Access Compliance Report

Public Rights-of-Way

(Curb Ramps)

Intersection ID: 47849	Main Street: SERAPE_RD	Cross Street: STONE_PORCH_RD	Location: SW
ADA ID: 442EFA770E7B	Ramp Type: BlendTrans2	Initial Pass/Fail: Fail	Overall Compliance: No
		Severity Score: 8.75

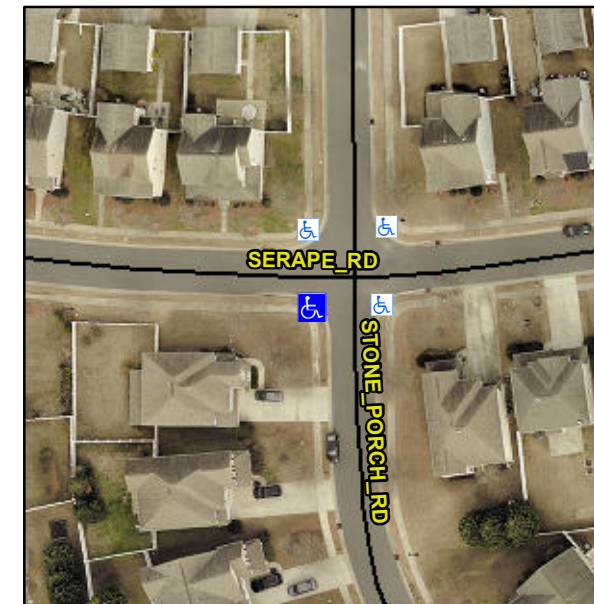
Not Found, R304.5.1

Compliance	Description	Data	Compliance	Description	Data
N/A	Ramp Length (in)	96.0	Yes	BlendTrans Slope (%)	4.6
No	Ramp Width (in)	46.5	Yes	BlendTrans XSlope (%)	1.5
N/A	Flare Type LT	N/A	N/A	Flare Type RT	N/A
N/A	Flare Slope LT (%)	N/A	N/A	Flare Slope RT (%)	N/A
N/A	Flare Traversable LT?	N/A	N/A	Flare Traversable RT?	N/A
N/A	Landing Length (in)	N/A	N/A	DWS Provided?	N/A
N/A	Landing Width (in)	N/A	N/A	DWS Contrast?	N/A
N/A	Landing Slope (%)	N/A	N/A	DWS Length (in)	N/A
N/A	Landing X Slope (%)	N/A	N/A	DWS Full Width?	N/A
N/A	Landing Curb? (Y/N)	N/A	N/A	DWS Offset (in)	N/A
N/A	Shared Landing?	N/A			
N/A	Gutter Ponding?	N/A	N/A	Gutter Slope (%)	N/A
N/A	Gutter Lip Ht (in)	N/A	N/A	Gutter X Slope (%)	N/A
N/A	Painted X Walk1?	No	N/A	Painted X Walk2?	No
	X Walk 1 Direction	To E		X Walk 2 Direction	To N
	X Walk 1 Width (in)	N/A		X Walk 2 Width (in)	N/A
	X Walk 1 Slope (%)	0.0		X Walk 2 Slope (%)	1.0
	X Walk 1 X Slope (%)	2.4		X Walk 2 X Slope (%)	0.2

N/A	Ramp inside XWalk1?	N/A	N/A	Ramp inside XWalk2?	N/A
	Road Slope (%)	1.6		Clear Space?	N/A
	Road X Slope (%)	2.7	N/A	Clear Space to XWalk (in)	N/A
N/A	Any Obstructions?	N/A	N/A	Storm Grate/Utility Hazard?	N/A
	Obstruction Type			Storm Grate/Utility Type	
		N/A			N/A
			Yes	Surface Condition? (G/P)	Good
			No	Curb Slope (%)	6.0

Remove & Replace Curb Ramp With Two New Directional Ramps or Equivalent.
